**RE: Mesa Del Sol Self Storage
5500 Turing Dr. SE
Grading and Drainage Plan
Engineer's Stamp Date: 5/7/2025
Hydrology File: R16DA1004**

**Re: Mesa Del Sol Self Storage
 5500 Turing Dr. SE
 Grading and Drainage Plan
 Engineer's Stamp Date: 01/15/2025
 Hydrology File: R16DA1004**

Here are the responses to the comments provided on March 21, 2025 in regards to an **Updated Grading & Drainage prior to continuing onsite grading and foundation work.**

CIVIL DETAILS.

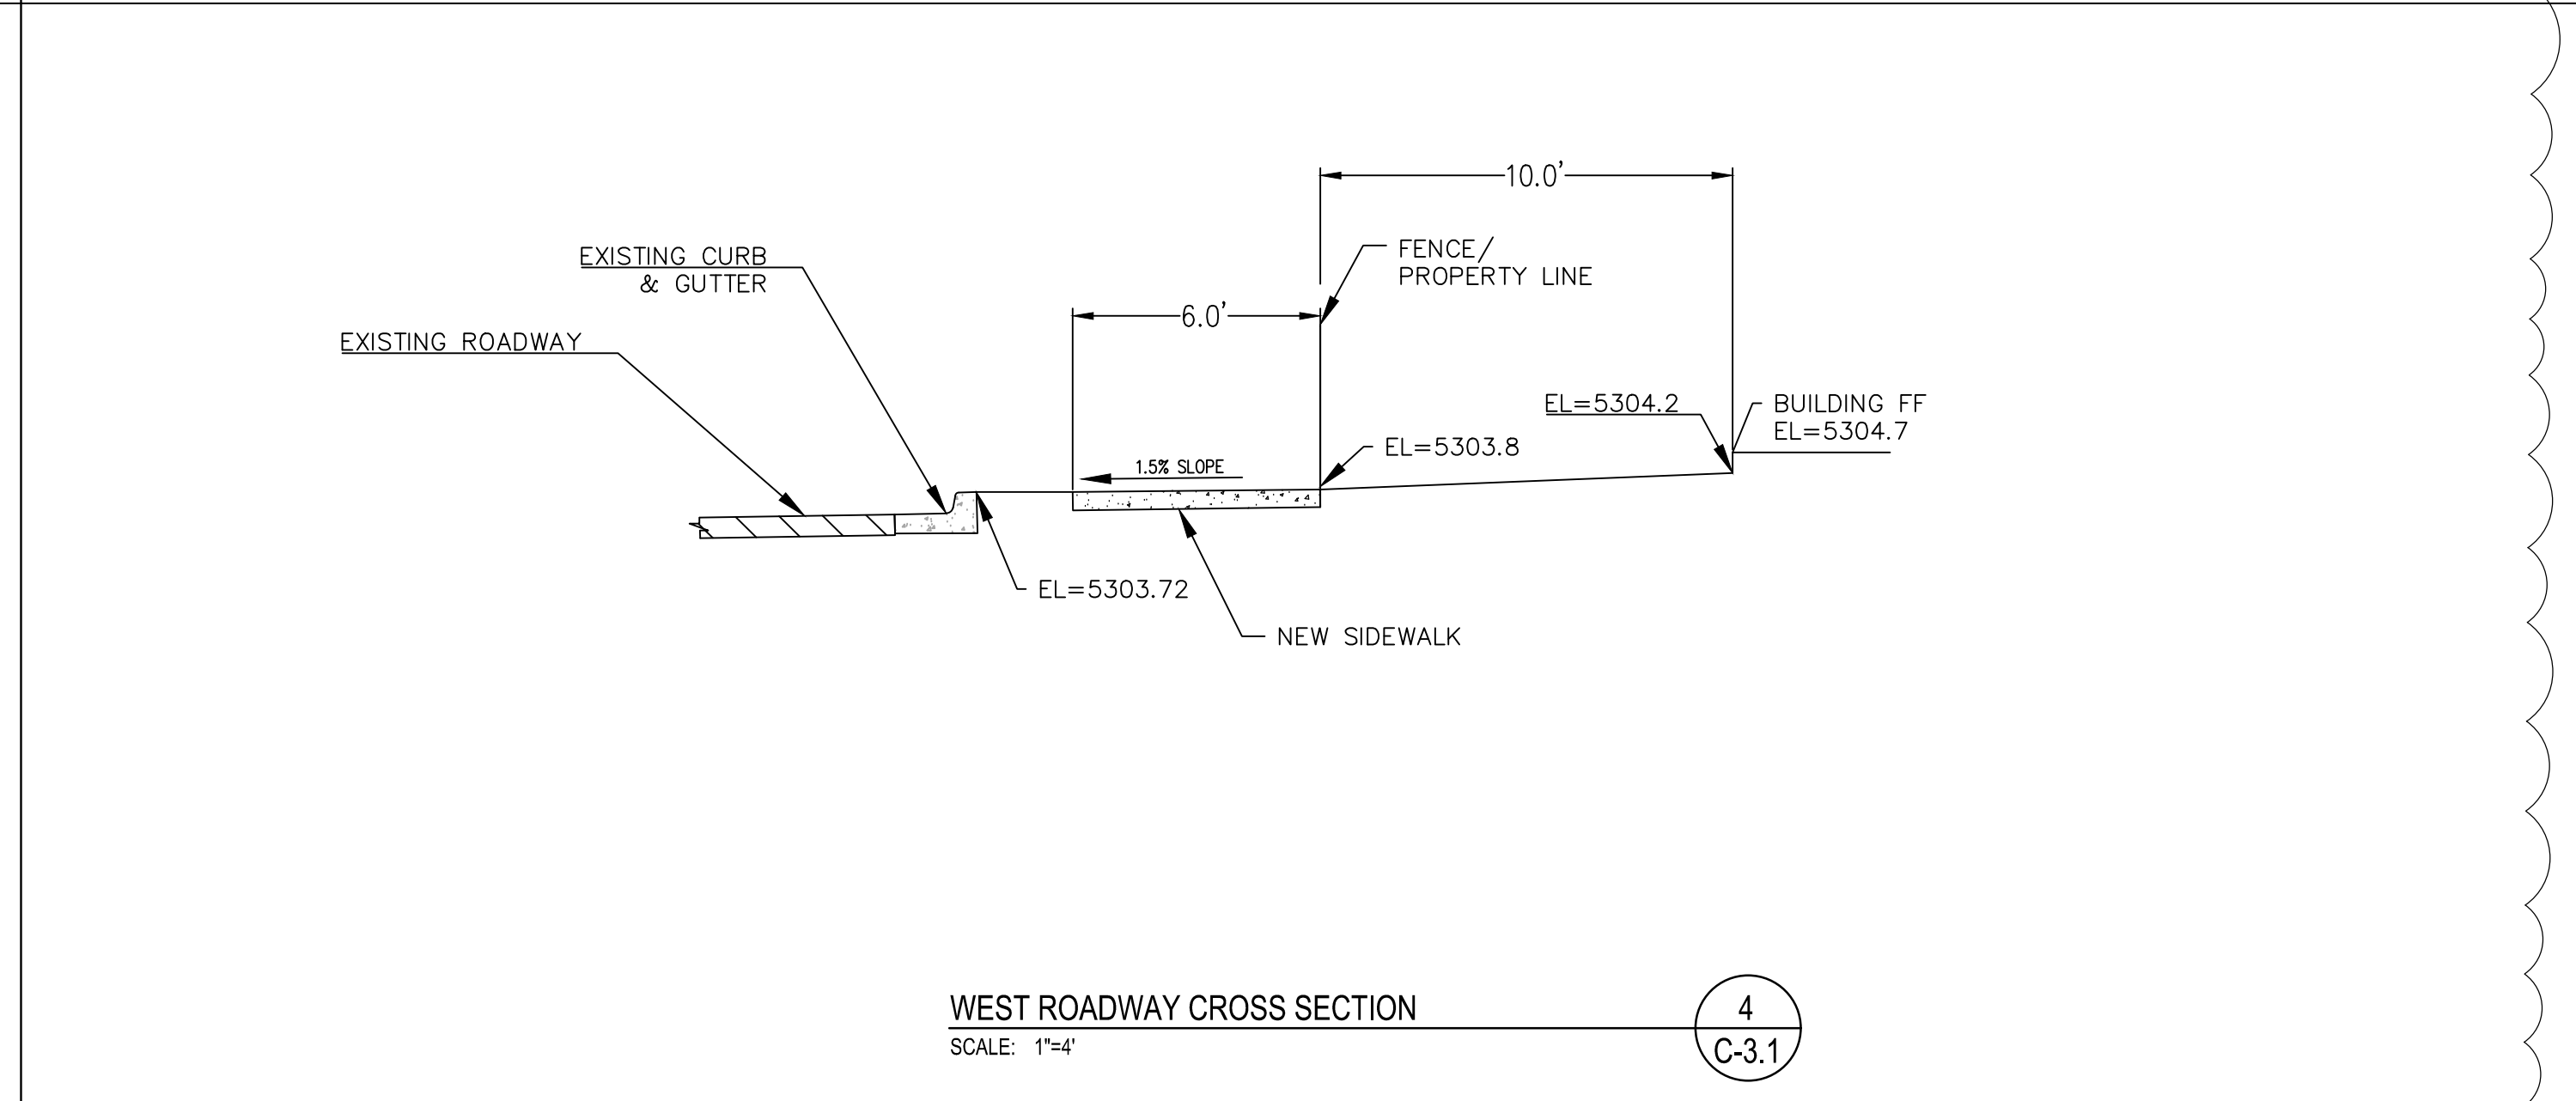
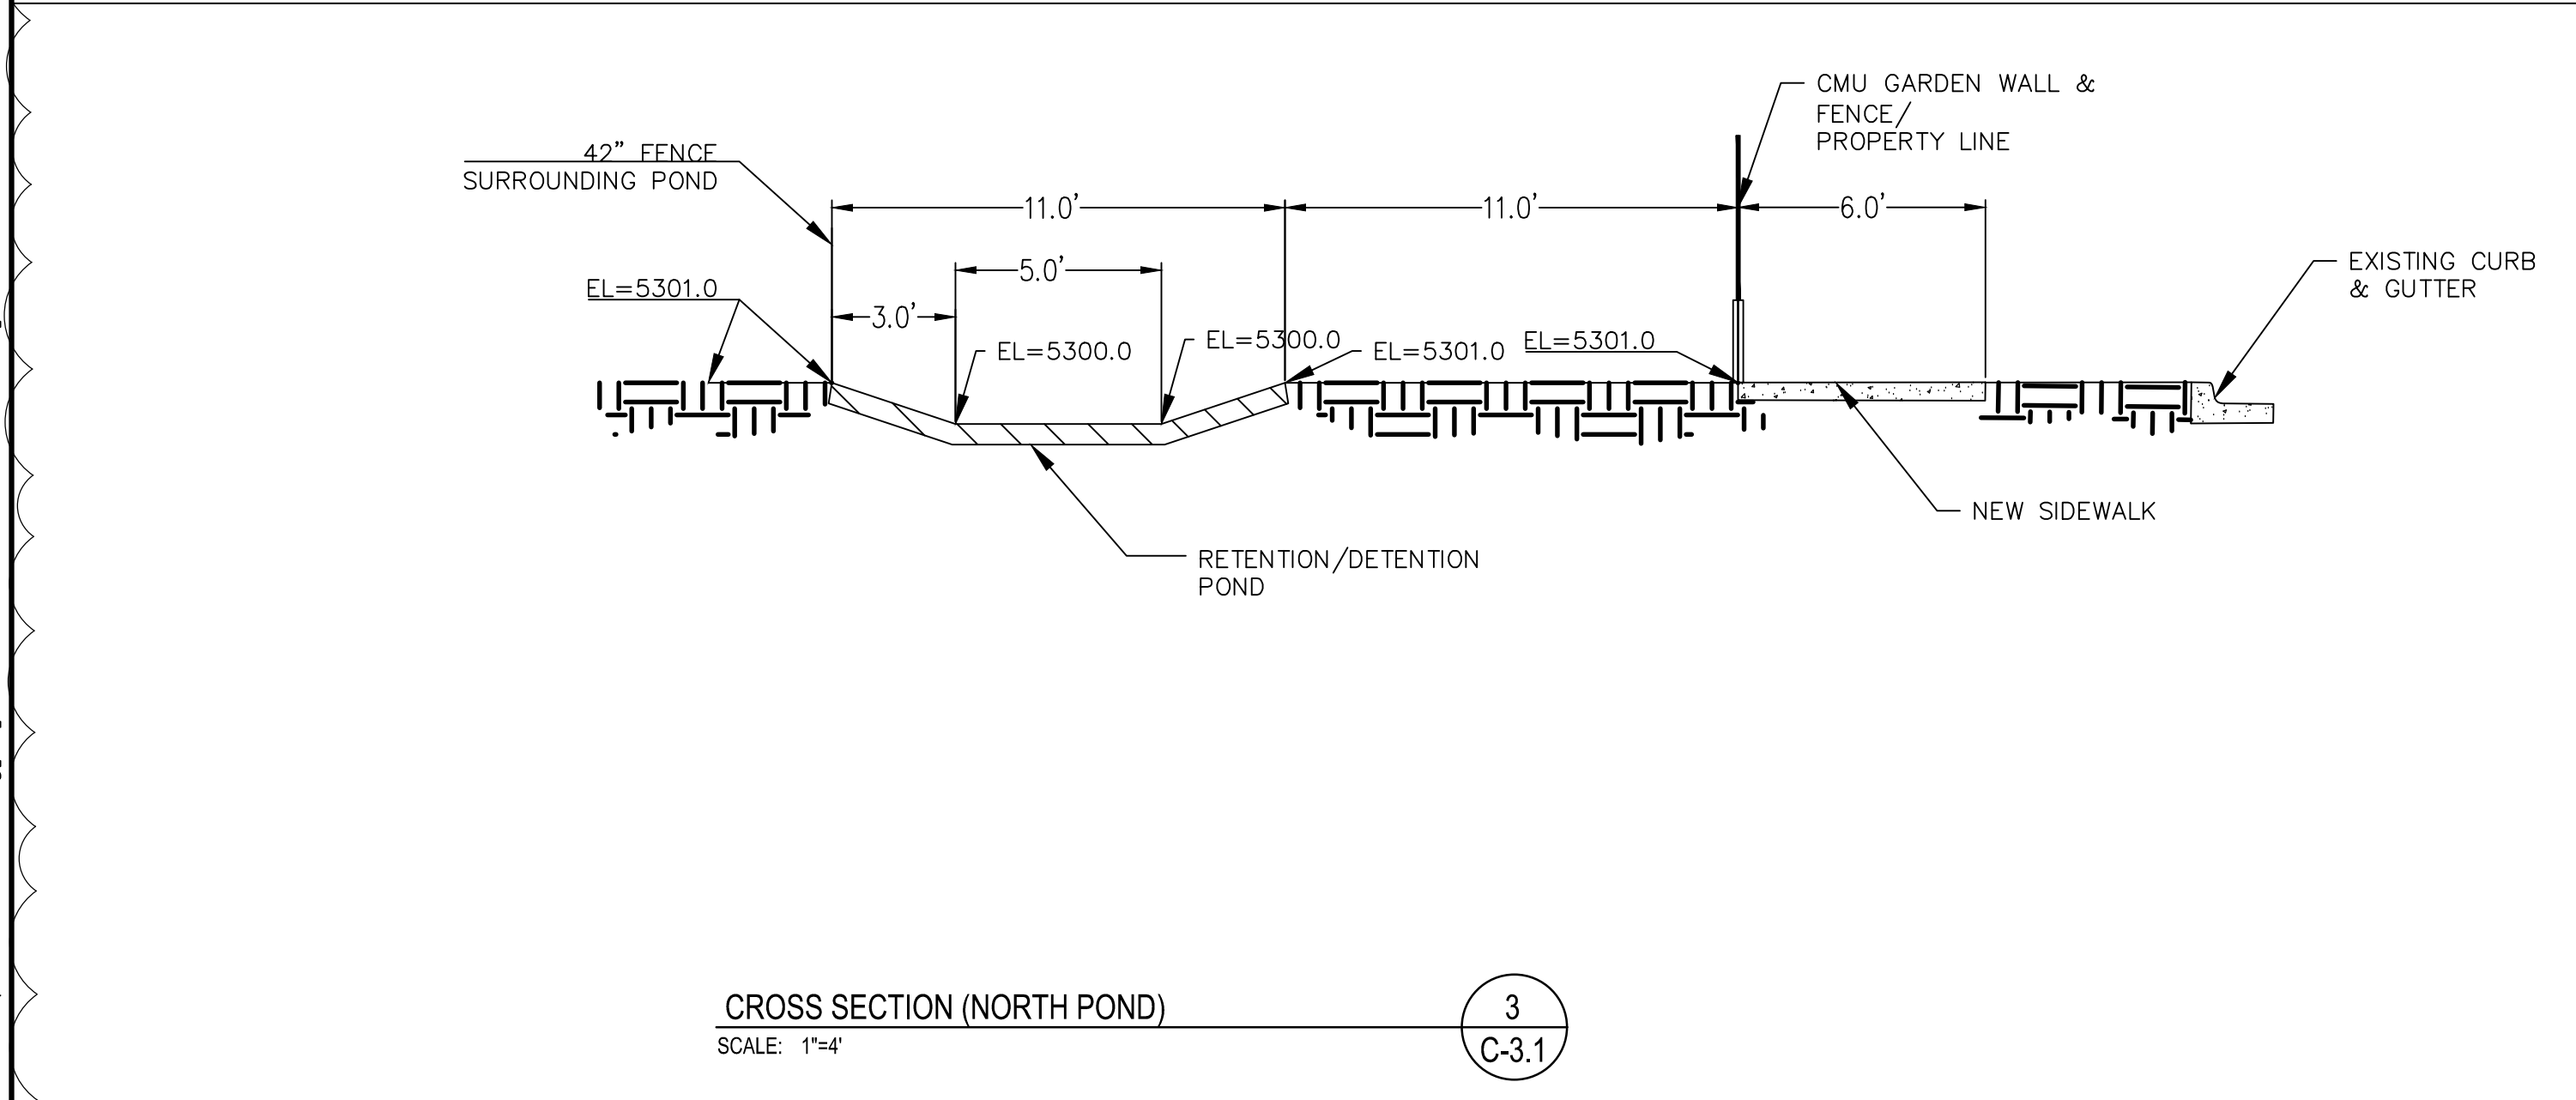
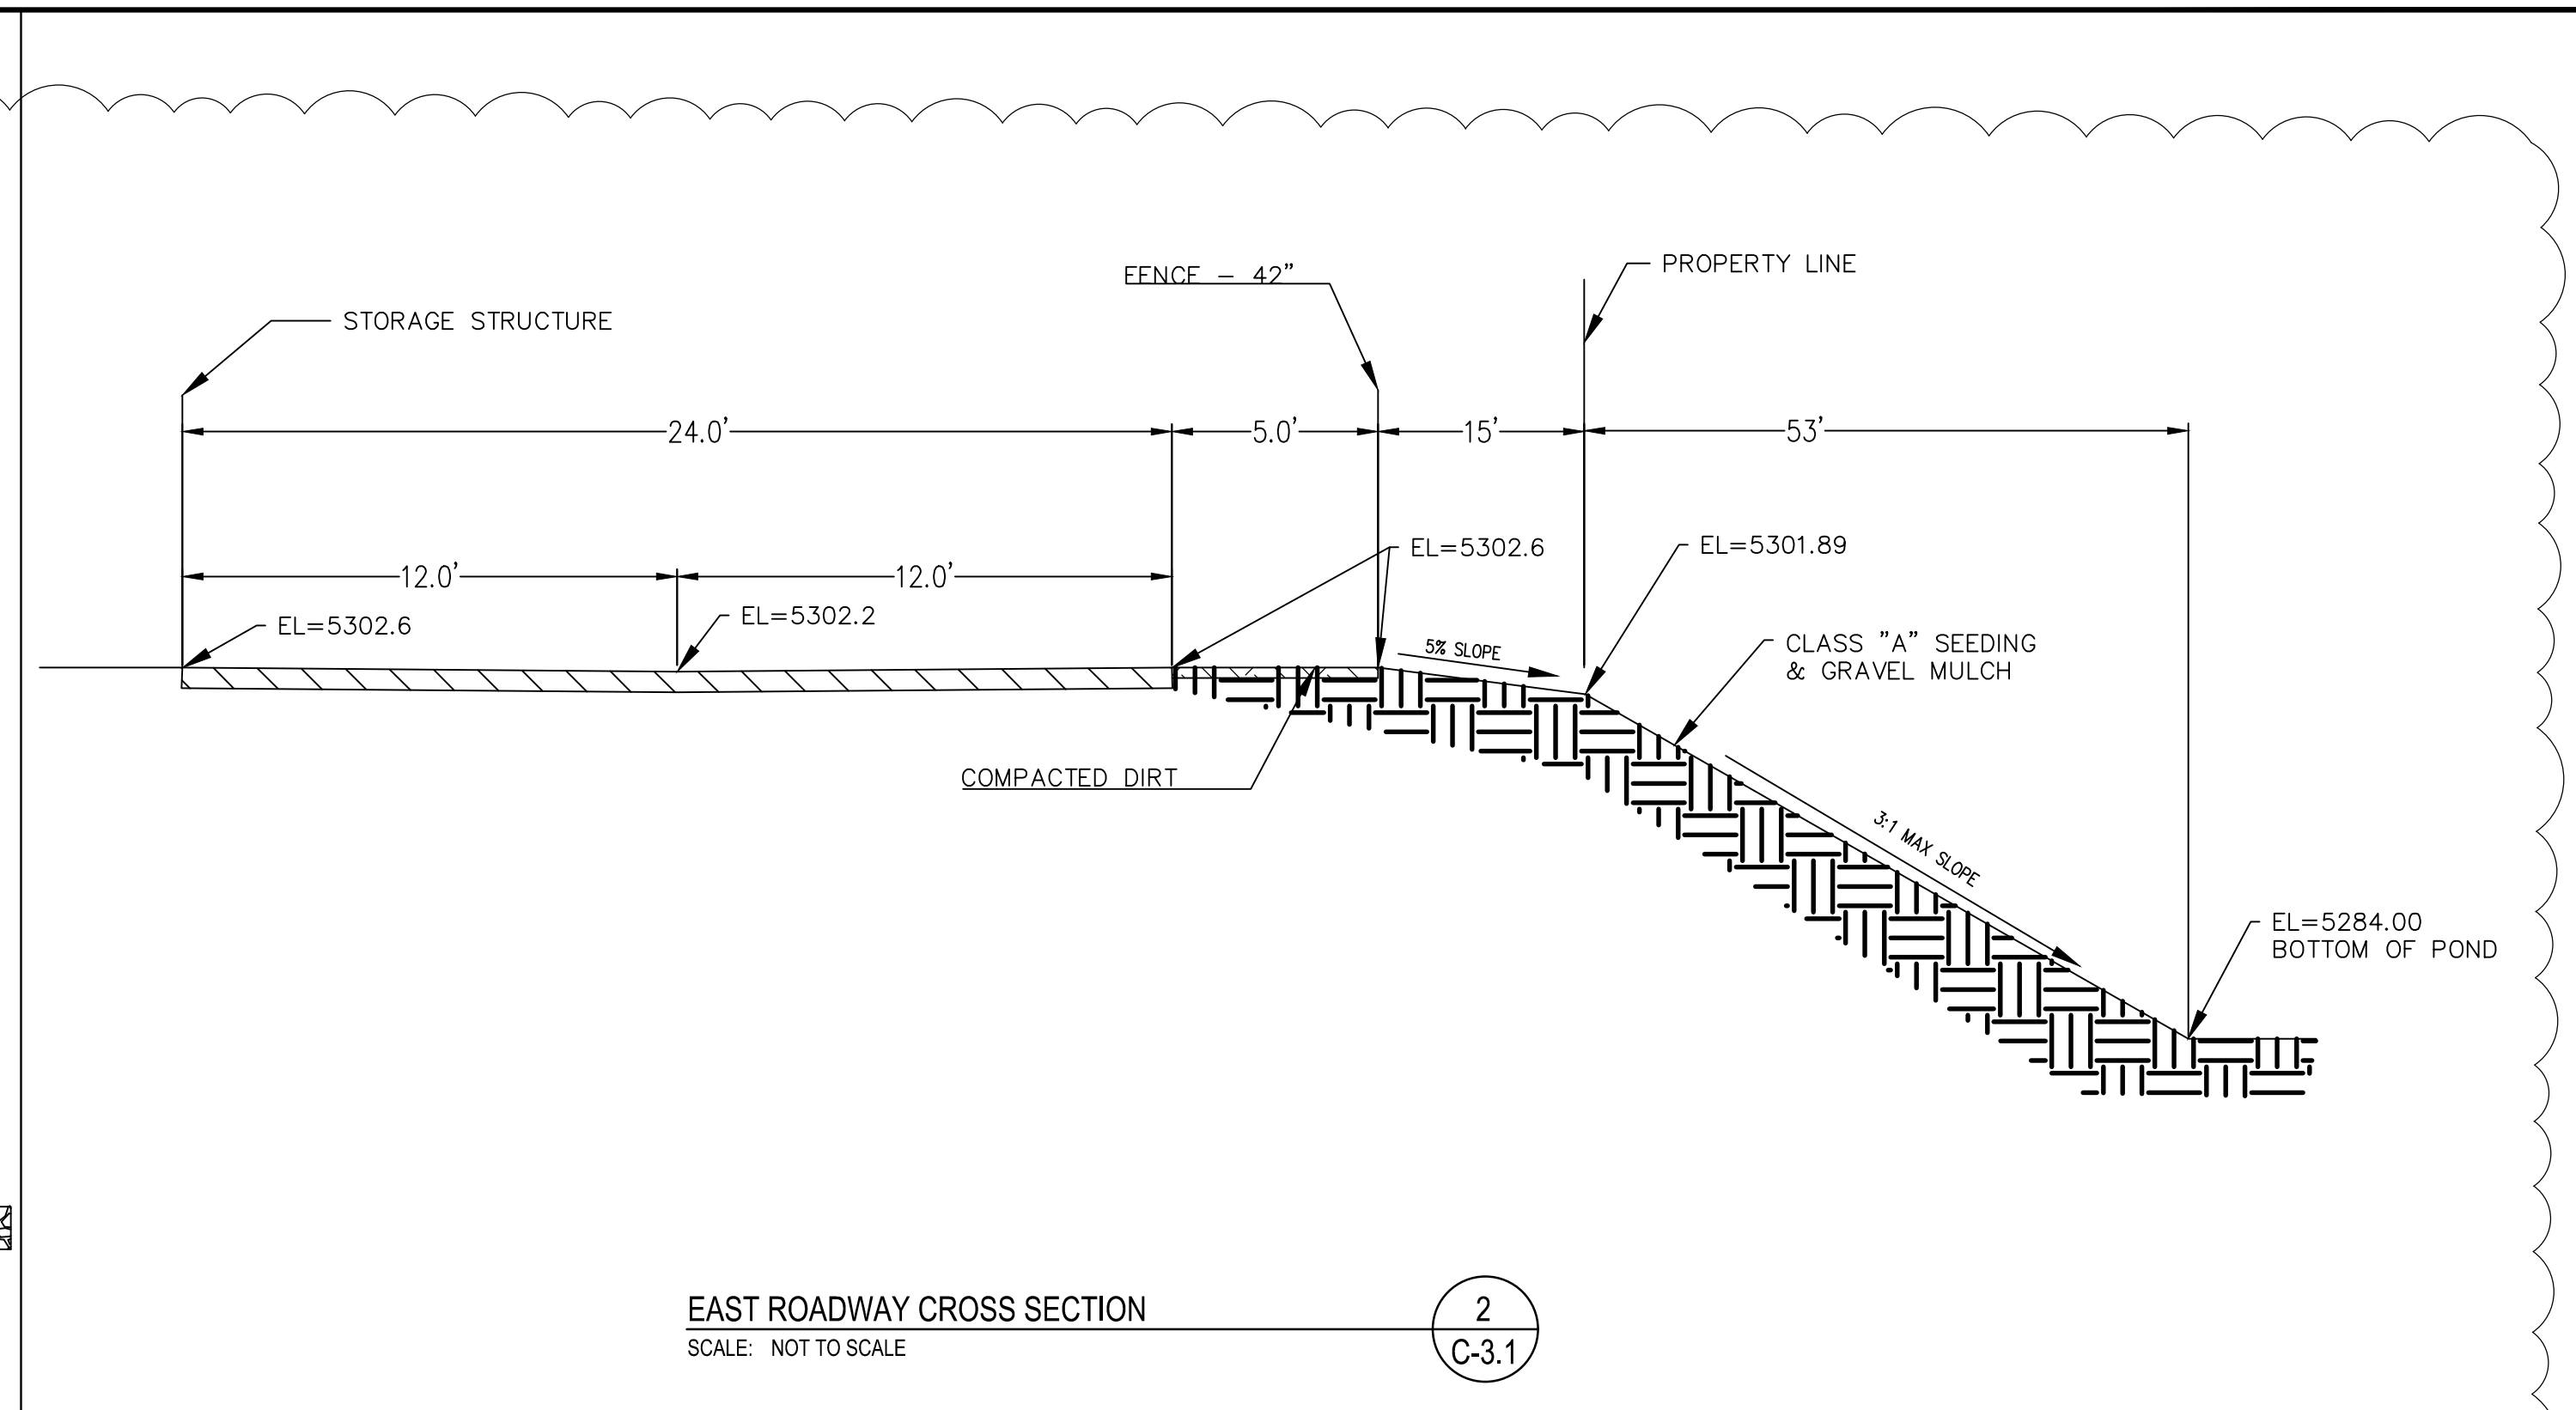
8. Due to the proposed retaining wall in Section 1 of C-3.1, provide an additional cross-section showing the existing storm drain manhole and pipe extension through the proposed retaining wall and into the retention basin at the southeast corner of the project.
Concur. Additional section has been added, see revised sheet C-3.1 & C-3.2. Retaining wall removed from revised design.
